UNITED STATES PATENT AND TRADEMARK OFFICE

APPLICATION NO.	FILING DATE	FIRST NAMED INVENTOR	ATTORNEY DOCKET NO.	CONFIRMATION NO.
10/656,259	09/08/2003	Wen-Han Hsieh	SUND 477	8609

Office Action Summary

DETAILED ACTION

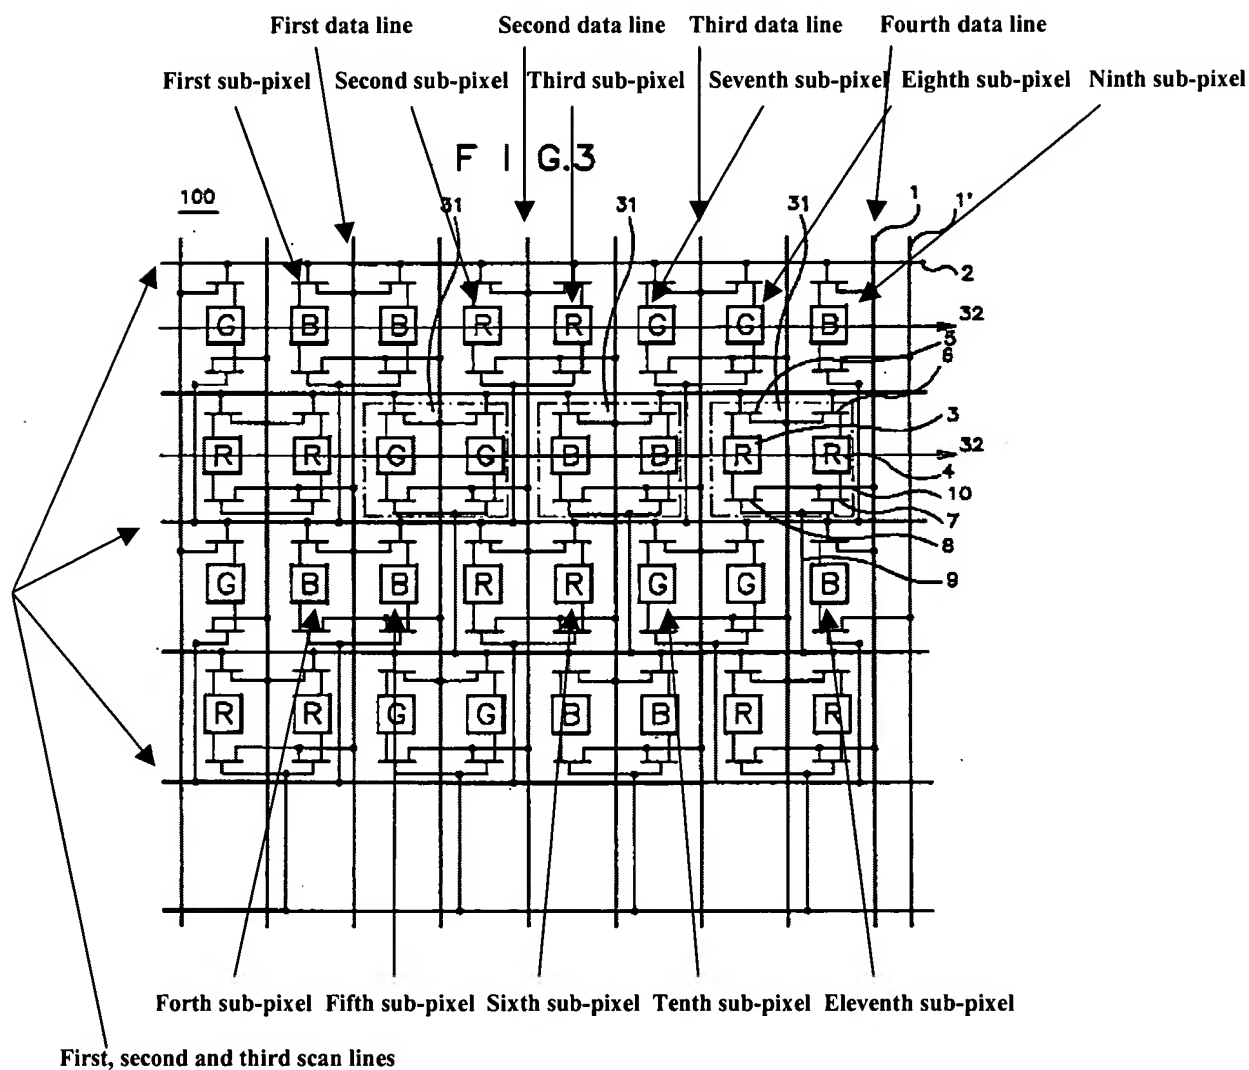
Referring to claim 1, Orgurstov et al. discloses a device comprising a first data line and a second data line, both of which being arranged substantially in parallel (Fig. 3, ref. 1); a first scan line, a second scan line, and a third scan line, all of which being arranged substantially in parallel and arranged in a matrix pattern together with the first data line and the second data line (Fig. 3, ref. 2); a first pixel comprising a first sub-pixel coupled to the first data line and the first scan line; a second sub-pixel coupled to the second data line and the first scan line; and a third sub-pixel coupled to the second data line and the second scan line; and a second pixel comprising a fourth sub-pixel coupled to the first data line and the second scan line; a fifth sub-pixel coupled to the first data line and the third scan line; and a sixth sub-pixel coupled to the second data line and the third scan line (see figure below), wherein when the first scan line is enabled, data on the first data line is input to the first sub-pixel and data on the second data line is input to the fourth sub-pixel; and when the third scan line is enabled, data on the first data line is input to the fifth sub-pixel and data on the second data line is input to the sixth sub-pixel (col. 5, lines 9-34; col. 7, lines 3-56).

Referring to claim 2, Ogurstov et al. discloses a device wherein the liquid crystal display is formed by repeatedly arranging the unit in a matrix pattern (Fig. 3).

Referring to claim 3, Ogurstov et al. discloses a device comprising a first data line, a second data line, a third data line, and a fourth data line, all of which being arranged substantially in parallel with each other (Fig. 3, ref. 1); a first scan line, a second scan line, and a third scan line, all of which being arranged substantially in parallel with each other and arranged in a matrix pattern together with the first data line, the second data line, the third data line, and the fourth data line (Fig. 3, ref. 2); a first pixel comprising: a first sub-pixel coupled to the first data line and the first scan line; a second sub-pixel coupled to the second data line and the first scan line, and a third sub-pixel coupled to the second data line and the second scan line; a second pixel comprising a fourth sub-pixel coupled to the first data line and the second scan line; a fifth sub-pixel coupled to the first data line and the third scan line; and a sixth sub-pixel coupled to the second data line and the third scan line; a third pixel comprising a seventh sub-pixel coupled to the third data line and the second scan line; an eighth sub-pixel coupled to the third data line and the first scan line; and a ninth sub-pixel coupled to the fourth data line and the first scan line; and a fourth pixel comprising: a tenth sub-pixel coupled to the third data line and the third scan line; an eleventh sub-pixel coupled to the fourth data line and the third scan line (see figure above);

wherein when the first scan line is enabled, data on the first data line is input to the first sub-pixel, data on the second data line is input to the second sub-pixel, data on the third data line is input to the eighth sub-pixel, and data on the fourth data line is input to the ninth sub-pixel; when the second scan line is enabled, data on the second data line is input to the third sub-pixel, data on the first data line is input to the fourth sub-pixel, data on the third data line is input to the seventh sub-pixel, and data on the fourth data line is input to the twelfth sub-pixel; and when the third scan line is enabled, data on the first data line is input to the fifth sub-pixel, data on the second data line is input to the sixth sub-pixel, data on the third data line is input to the tenth sub-pixel, and data on the fourth data line is input to the eleventh sub-pixel (col. 5, lines 9-34; col. 7, lines 3-56). However, the reference does not disclose that a twelfth sub-pixel is coupled to the fourth data line and the second scan line.

It would have been obvious to one having ordinary skill in the art at the time the invention was made to employ a twelfth sub-pixel is coupled to the fourth data line and the second scan line since although the reference does not show the twelfth sub-pixel, one having ordinary skill in the art at the time the invention was made would have known to include the twelfth sub-pixel following the eleventh sub-pixel in order to provide a full display. Figure 3 is a representation of a only a portion of the pixels of an entire display. As disclosed by Ogurstov et al. the illustration shown in Figure 3 is a plan view of only “a part of a liquid crystal display” (col. 4, lines 47-48). Therefore, one having routine skill in the art would have expected at least an extra column of pixels on the right side of the figure. As can be clearly seen from pattern of figure 3, each blue sub-pixel is adjacent to another blue sub-pixel. Therefore, since the reference states that the figure is only a part of a liquid crystal display, one would expect that another blue

sub-pixel would be situated to the right of the eleventh sub-pixel. Furthermore, as can be seen from the fourth sub-pixel and the fifth sub-pixel, both sub-pixels are connected to the first data line and second scan line. Therefore, following such a pattern, one having routine skill in the art would have expected that a twelfth sub-pixel situated to the right of the eleventh sub-pixel would be connected to the fourth data line and the second scan line. One having routine skill in the art would know that LCD's generally follow a consistent pattern, allowing consistency across the full display. Even though Figure 3 only shows a portion of the display, one would have reasonably expected that the rest of the display would follow the same pattern.

Referring to claim 4, Ogurstov et al. disclose the device wherein the liquid crystal display is formed by repeatedly arranging the unit in a matrix pattern (Fig. 3).
